SUBSURFACE WASTEWATER DISPOSAL SYSTEM APPLICATION

Town or Plantation	AUBURN
Street Address	1369 OLD DANVILLE RD.
Subdivision Lot #

Subject: Approval Replacement System Variance Request, Michaud property, Old Danville Road, Auburn

REPLACEMENT SYSTEM VARIANCE REQUEST

SUBSURFACE WASTEWATER DISPOSAL PLAN

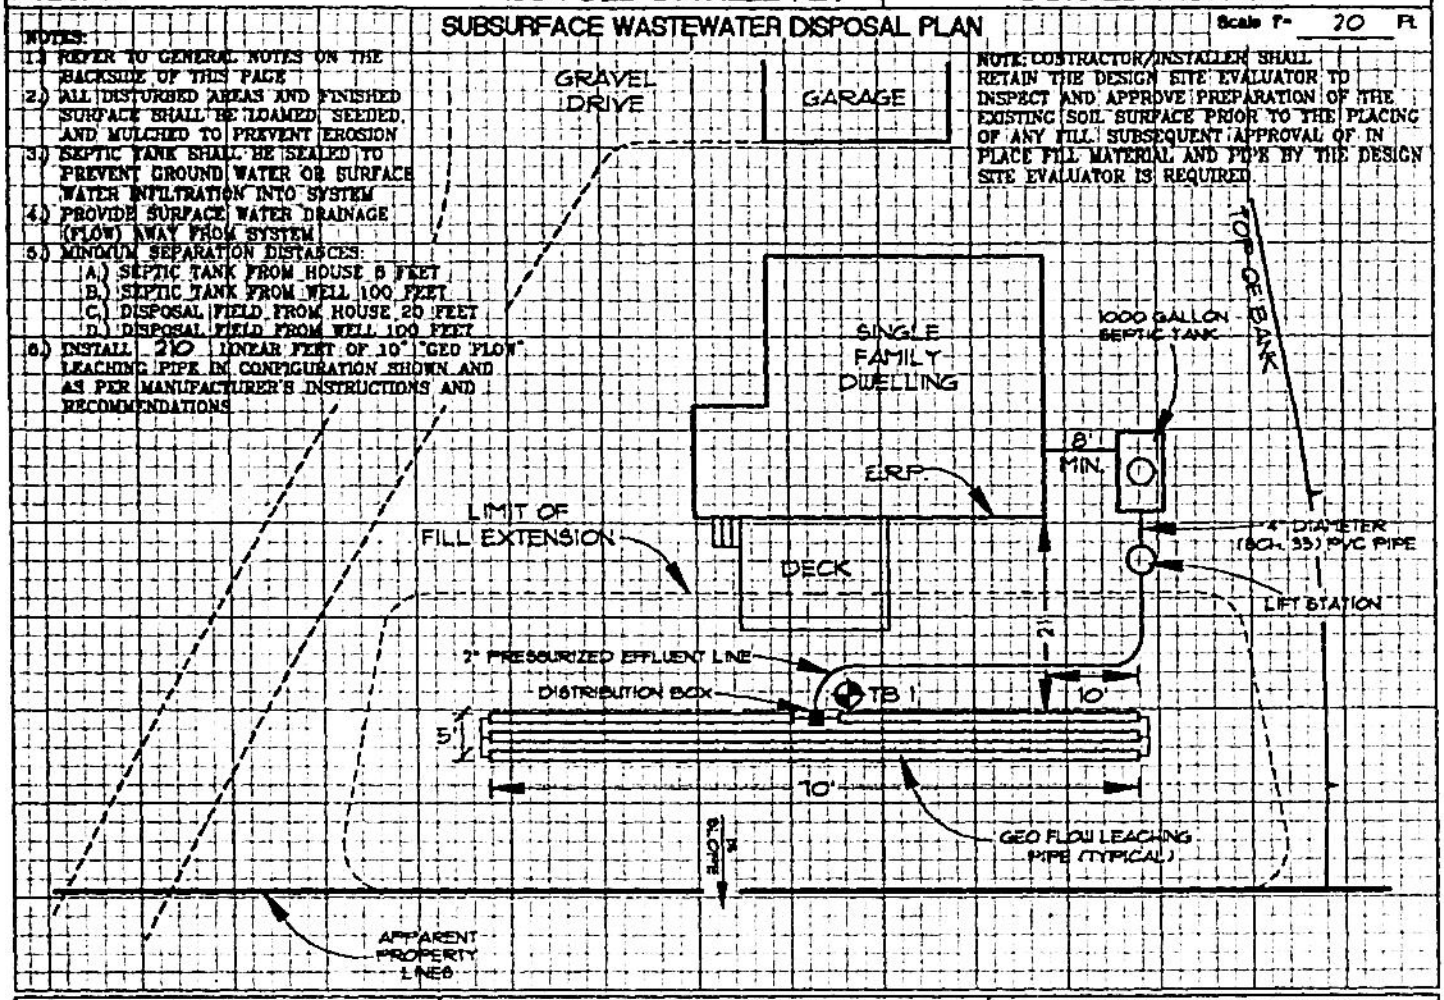
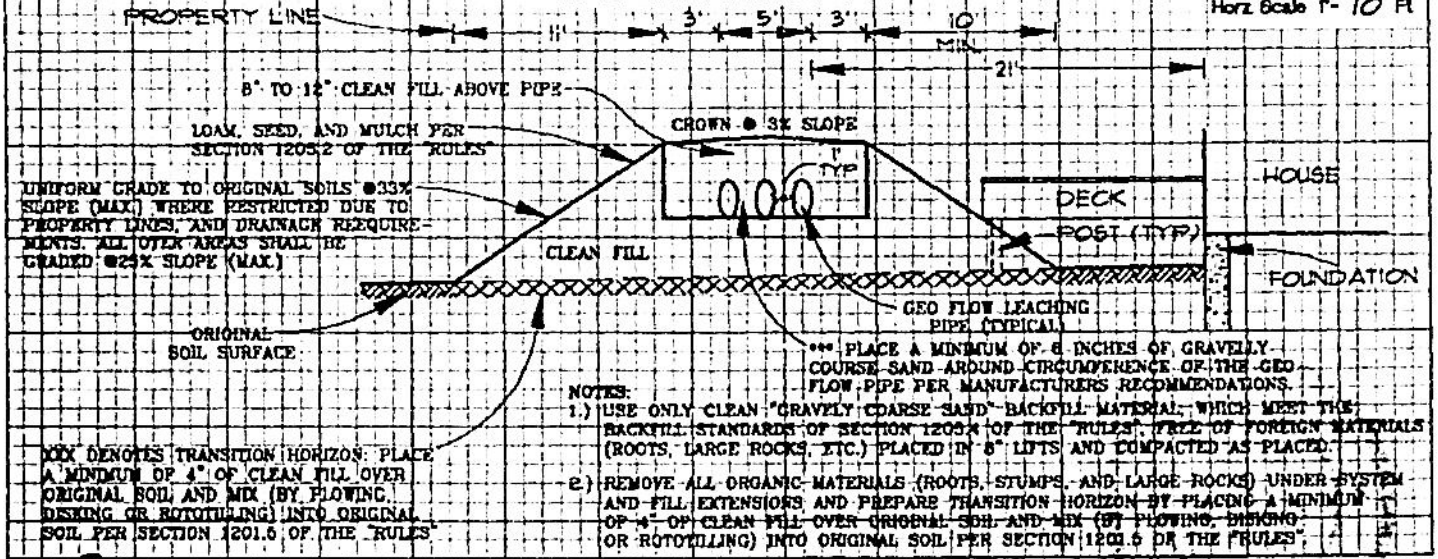
The Division has reviewed a Replacement System Variance Request for the subject property. The state variance request is to allow the installation of a subsurface wastewater disposal system in soils with six inches to the groundwater table and six inches to the restrictive layer. Also requested is three foot shoulders rather than five foot and one foot separation between the pipes rather than two feet. The system design prepared by George Bouchles, SE, dated 7-28-98, is found to be in compliance with the Maine Subsurface Wastewater Disposal Rules.

We approve the requested variance(s) with the following requirements:

1. A permit for system installation is to be obtained from the Local Plumbing Inspector in advance of the start of system construction.

2. The system is to be installed in accordance with the submitted and approved system design. Should alterations be required at the time of system installation, the system designer must be notified prior to making any changes.
